## Application for Works Approval

**Works Approval Number** W6409/2020/1

**Applicant** Pilbara Iron Company (Services) Pty Ltd

**Premises** Greater Tom Price Iron Ore Mine  
Mining tenement AML70/4 sections 1-7, 10, 13, 232 – 235, 258,  
L47/136, L47/209, L47/210, L47/342, L47/645, AG70/3,  
G47/1258 and L47/668  
MOUNT SHEILA WA 6751  
As defined by the Premises map attached to the issued works  
approval

**Figure 2: Layout of the proposed SEP WFSF and deposition infrastructure**

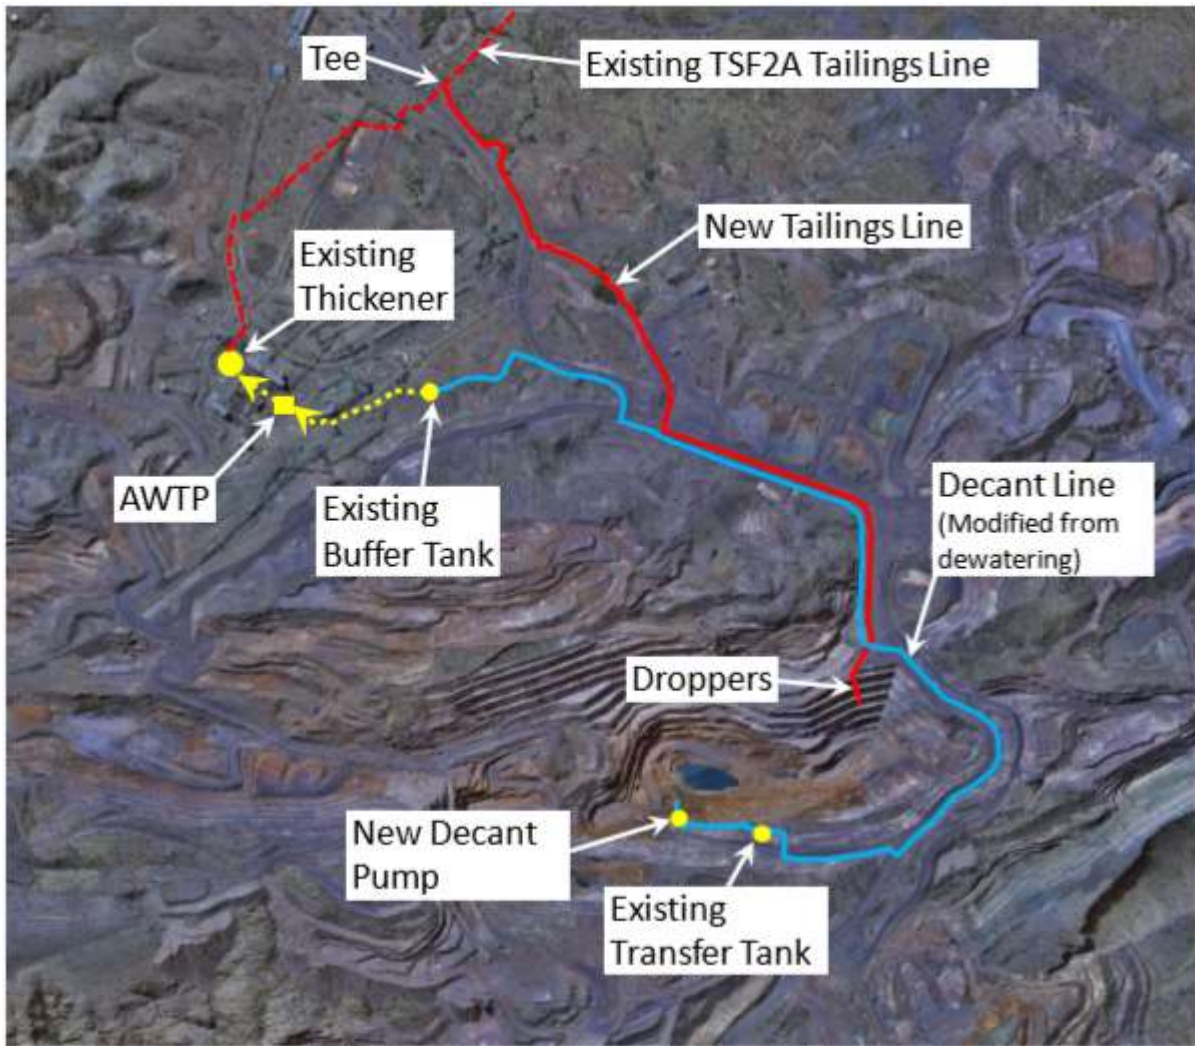
Works Approval Condition 21(e)	<p>The applicant requests monitoring be compared against ANZECC (2000) Guidelines for Livestock Drinking Water, taking into consideration background water quality.</p>	<p>As per the department's decision in section 3.4 this will be retained as Australian Drinking Water Guidelines based on the proposed SEP WFSF being located within the Priority 1, Paraburdoo Water Reserve PDWSA.</p>
Decision Report Figure 2	<p>The Licensee requests Figure 2: Layout of the proposed SEP WFSF and deposition infrastructure be updated with Figure 1 which presents a change in route for the first 1800m of tailings line</p> <p>After the completion of a closure study for TSF2A it was determined that filling TSF2A gradually by depositing there once a year during the dry season would provide a better closure outcome, minimising decant pond and building the desired closure profile.</p> <p>This change in operating philosophy means that a separate flushing system is not required (utilising the clarified water to flush as per current process), meaning tie into the line near the thickener is no longer necessary. This allows the tie-in point to be moved away from the plant, simplifying the design and operation.</p> <p>This new route will have better bunding and access as it follows the LV road and utilises the existing decant pipeline corridor, allowing easier monitoring and improved containment.</p>	<p>Figure 2 has been updated with the new figure provided by the applicant.</p>

**Figure 3: SEP monitoring bore locations**

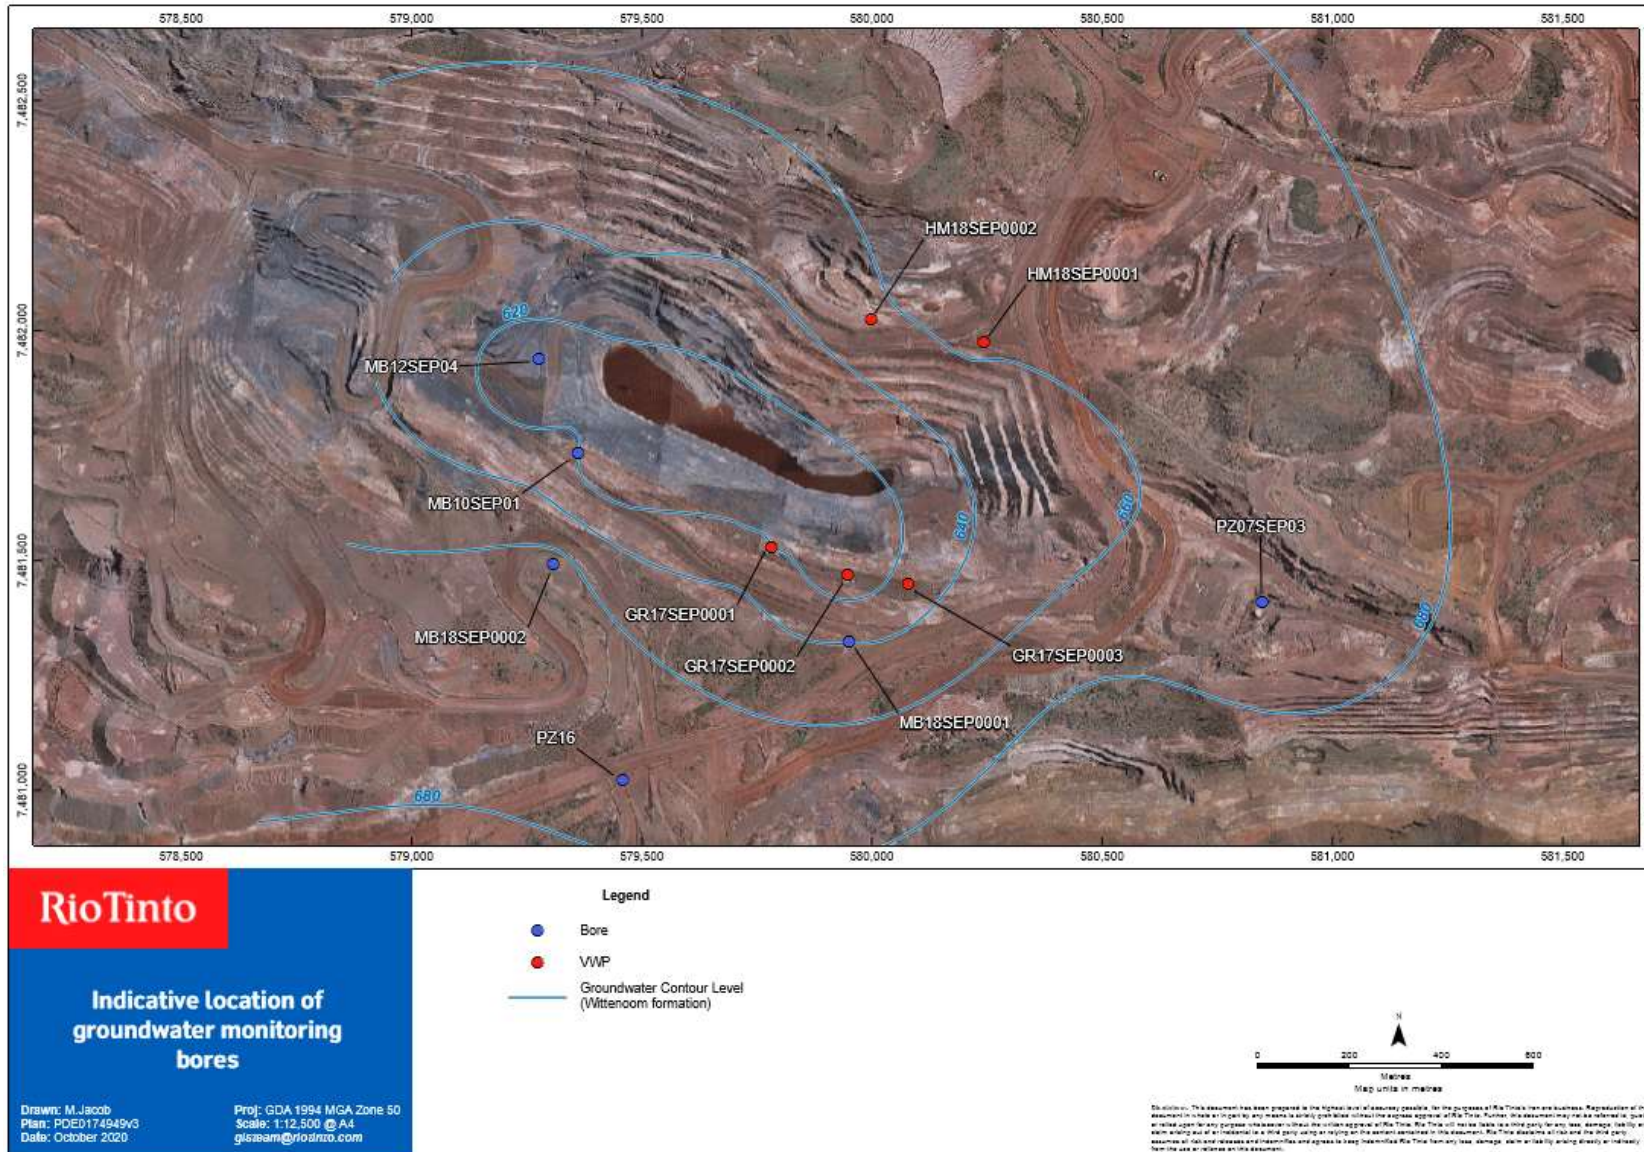
The applicant has proposed ambient groundwater monitoring as per Table 2 and at the locations specified by Figure 3. The applicant has also reviewed its conceptualisation and now considers three additional infill bores in advance of environmental commissioning to be adequate to enable radial monitoring for emissions (RTIO 2020b). Under this works approval the three additional monitoring bores will be installed in the vicinity of the SEP WFSF.

Grounds: The department will adopt a precautionary approach with respect to seepage from the SEP WFSF as the proposed SEP WFSF is located within the Priority 1, Paraburdoo Water Reserve PDWSA.

Design requirements for the construction and installation of the three new monitoring bores have been included to ensure bores are installed correctly and able to detect contamination (if applicable).

Monitoring of ambient groundwater levels and quality is required to determine if the SWL is changing indicating seepage from the WFSF or water quality is deteriorating. Comparison to the *NHMRC NRMCC 2011* is required as the proposed SEP WFSF is located within the Priority 1, Paraburdoo Water Reserve PDWSA. Monitoring prior to environmental commissioning is required to ensure that baseline groundwater quality data can be collected and used as a comparison against results obtained during commissioning and operation.
